In reference to Report No. DC 89, "Inspection of Leaks and Cracks in the (A) Steam Generator at H. B. Robinson II," June 23, 1971, I would like to offer the following opinions and recommendations:

CLADDING SEPARATION IN STEAM GENERATOR NOS. 1 AND 3 (SUPPLEMENTAL INFORMATION TO INQUIRY REPORT NOS. 71-11, 71-12 AND 71-13)

Report on
Inspection of Leaks and Cracks in the
(A) Steam Generator at H. B. Robinson II

Report No. DC 89

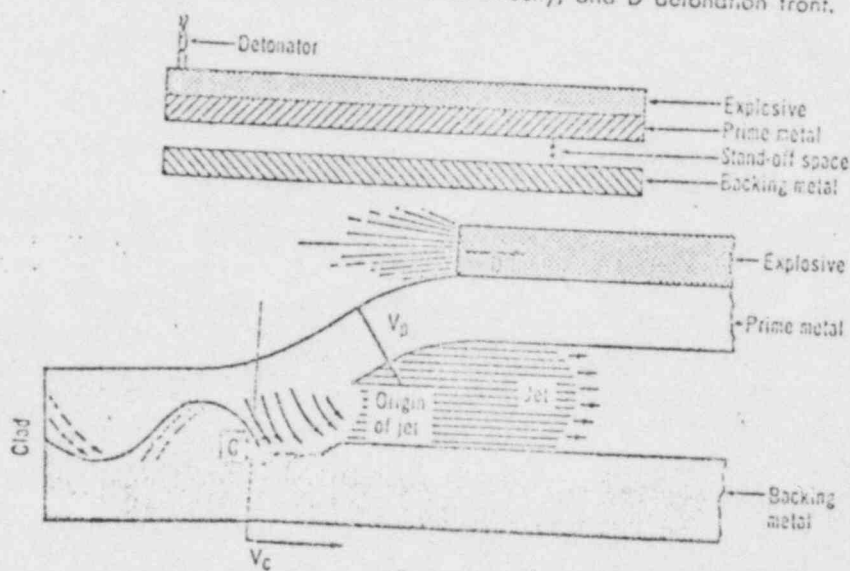
- (1) Westinghouse is primarily placing the blame for this leakage and cracking problem on the inadequacy and reliability problems associated with the explosion bonding cladding process. There is justification in placing high suspicion on this process. Experience has indicated that inconsistent bond integrity has been obtained on large, relatively complicated parts. For example, bond adhesion problems might be expected to localize in the central and outer edge portions of a component such as the steam generator. Although the basic principles and potential of this process have merit, the application of the process to various components often presents considerable practical difficulties.

The process dates back to the late 1950's and early 1960's and, is generally based on the Cowan, G. R., Douglass, J. J., and Holtzman, A. H., U.S. Patent No. 3,137,937 issued June 3, 1964 and assigned to E. I. du Pont de Nemours and Co. A typical cladding arrangement, as well as the basic operating principles are illustrated in Figure 1. After the explosive is detonated, the prime metal is accelerated very rapidly to a high velocity (V_p) by the detonation pressure. As the detonation front (D) moves across the plate, an angle is established between its undeflected and deflected portions. When the deflected portion of the prime metal collides with the backer plate, the region of high-pressure collision moves across the plates at high speed. This velocity (V_c) equals the detonation

Based on this failure and past experiences of manufacturers of large vessels, it is recommended that past and intended future application of this process be thoroughly reviewed.

FIG. 1
"A" STEAM GENERATOR

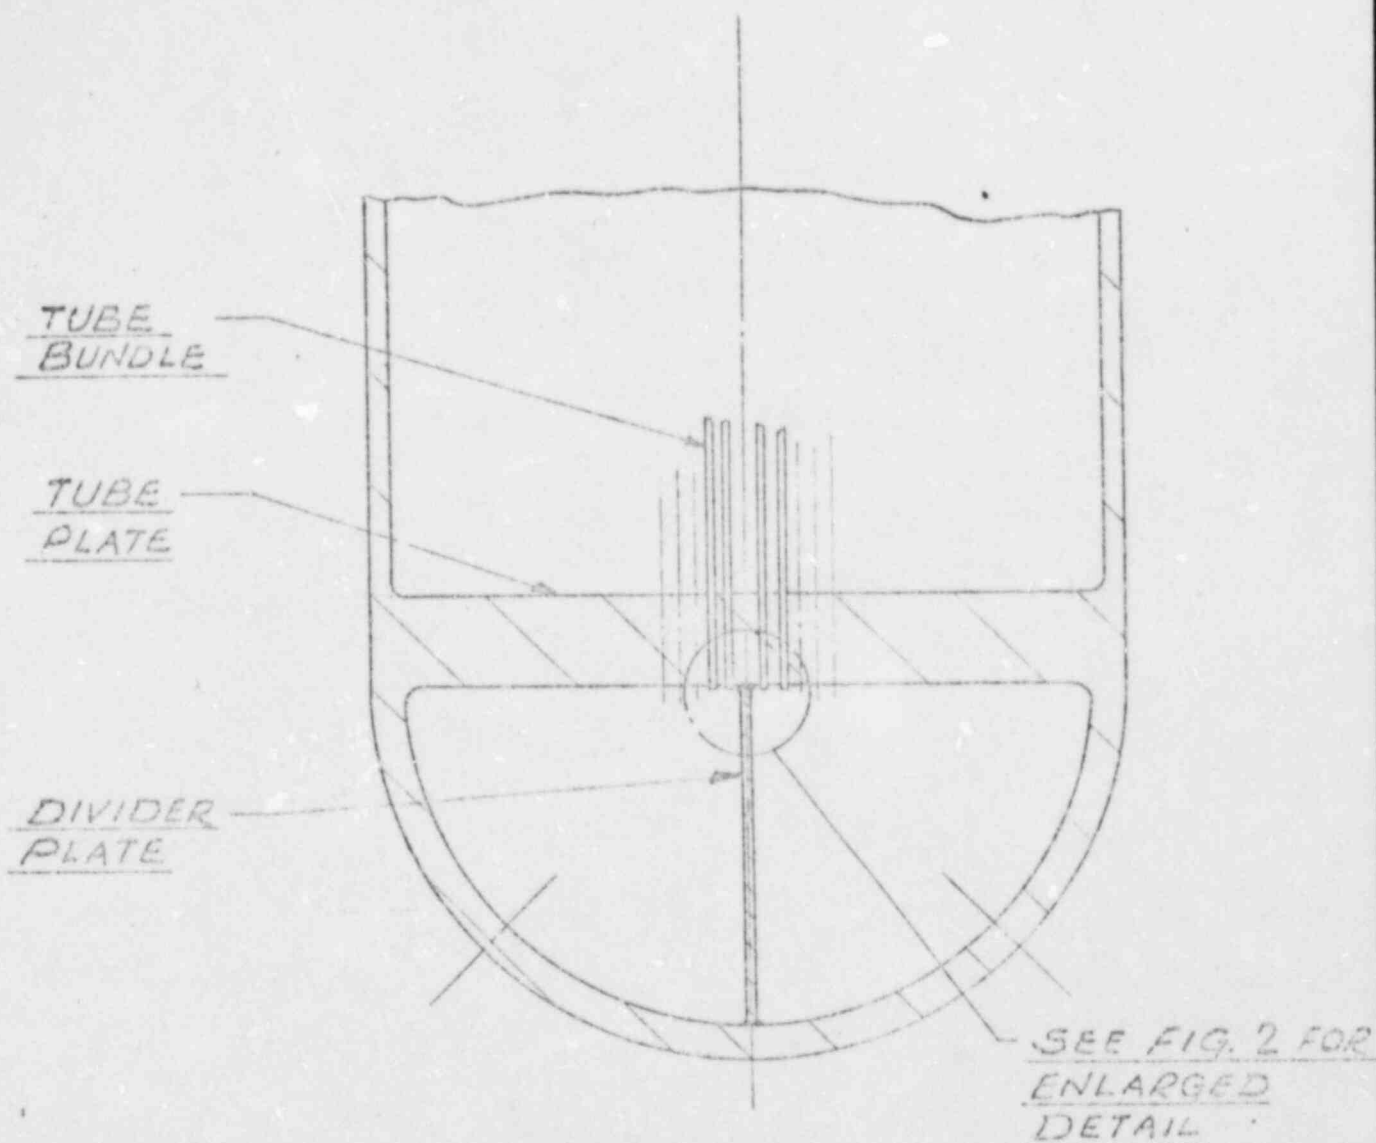
Mr. Kirkpatrick and the writer were "suited-up" and proceeded to enter individually and inspect the cold leg of the A steam generator. The inspection was performed visually using a low power magnifying lens. Mr. Kirkpatrick attempted to photograph the conditions we observed with a 35 mm. camera using a close-up lens. The following conditions were observed during this inspection: (See Figs. 1, 2 & 3)

- (1) Severe cracks were present in the fillet welds of approximately 30 tubes. The highest intensity of fillet cracking was apparent in the region included in and surrounding the 35th

FIG. 2
ENLARGED VIEW OF
CLAD SEPARATION

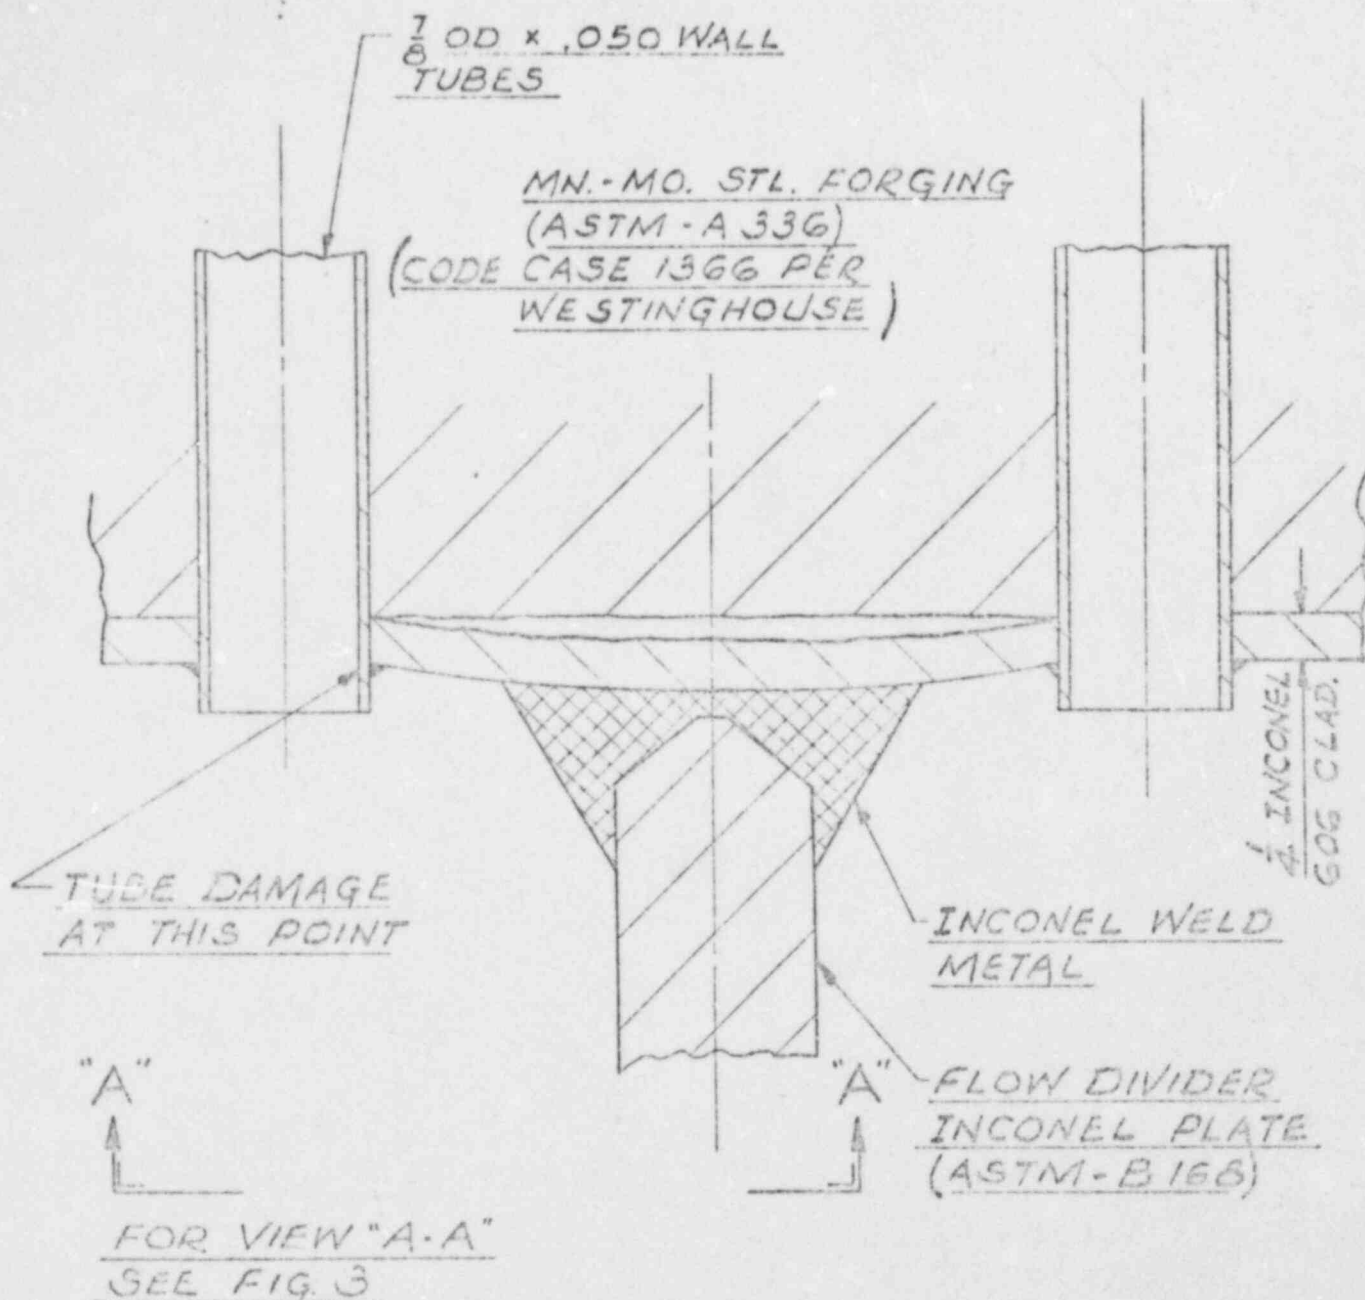
to 45th tubes (accounted from the north toward the south). These cracks were opened approximately .030 to .050 inches and were approximately semi-circular on the side of the fillet welds facing the flow divider plate.

- (2) Cracking in the 1/4 inch thick cladding was extensive in the region described above. These cracks were linear in the north-south direction (parallel to the divider plate) and were located approximately in line with the center of the first row of tubes. These cracks were tighter than those observed in the fillets and appeared to range in the vicinity of .005 to .010 inches wide and extended the entire length of the cladding between the cracked tubes.

APPROX. .030 TO .050
WIDE CRACKS IN
FILLET WELDS APPROX.
SEMI-CIRCULAR ON THE
SIDE OF WELDS FACING
THE FLOW DIVIDER
PLATE.

APPROX. .005 TO .010
WIDE CRACKS IN
CLADDING APPROX.
ON ϕ OF TUBES
EXTENDING THE
ENTIRE LGTH.
BETWEEN TUBES.

FIG. 3
VIEW "A-A"
FROM FIG. 2

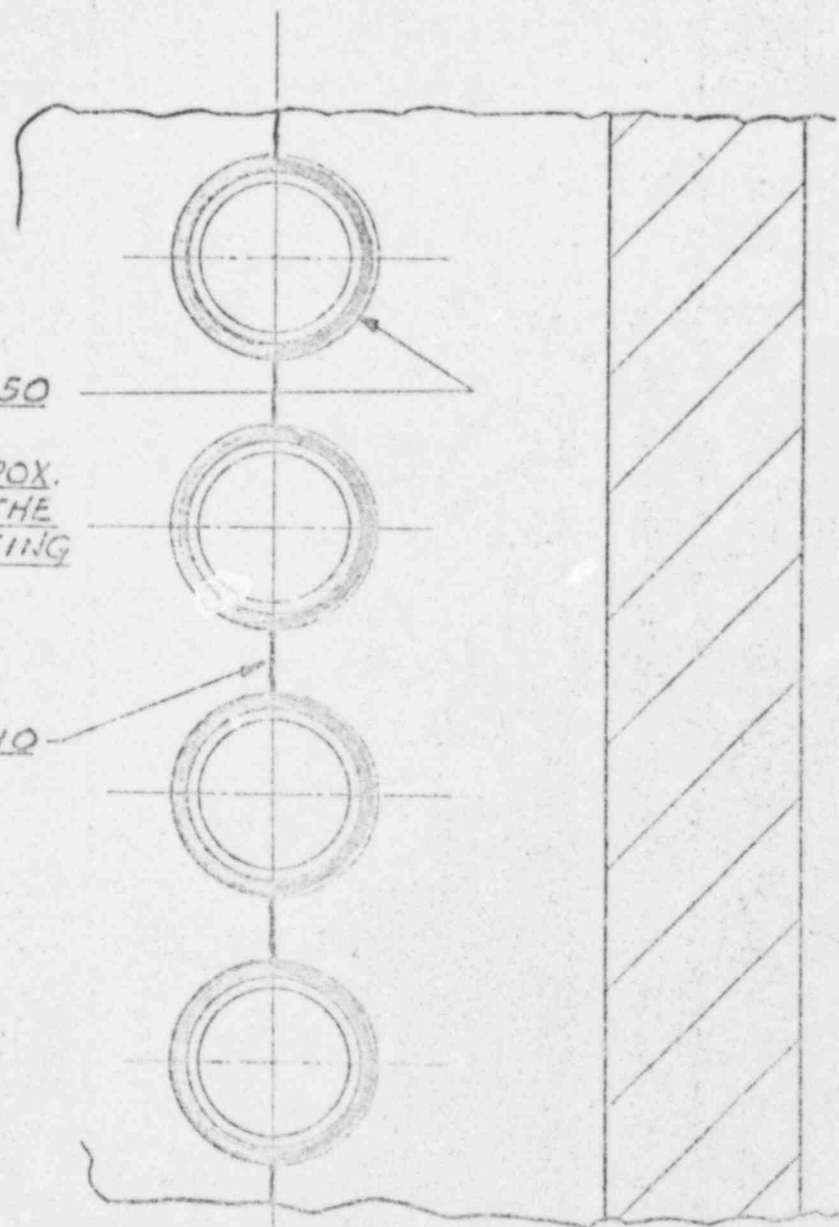
- (4) The writer visually observed a contoured region of the cladding, adjacent to the divider plate and in the vicinity of the 40th to 50th tubes that showed definite signs of having been separated from the tube sheet.
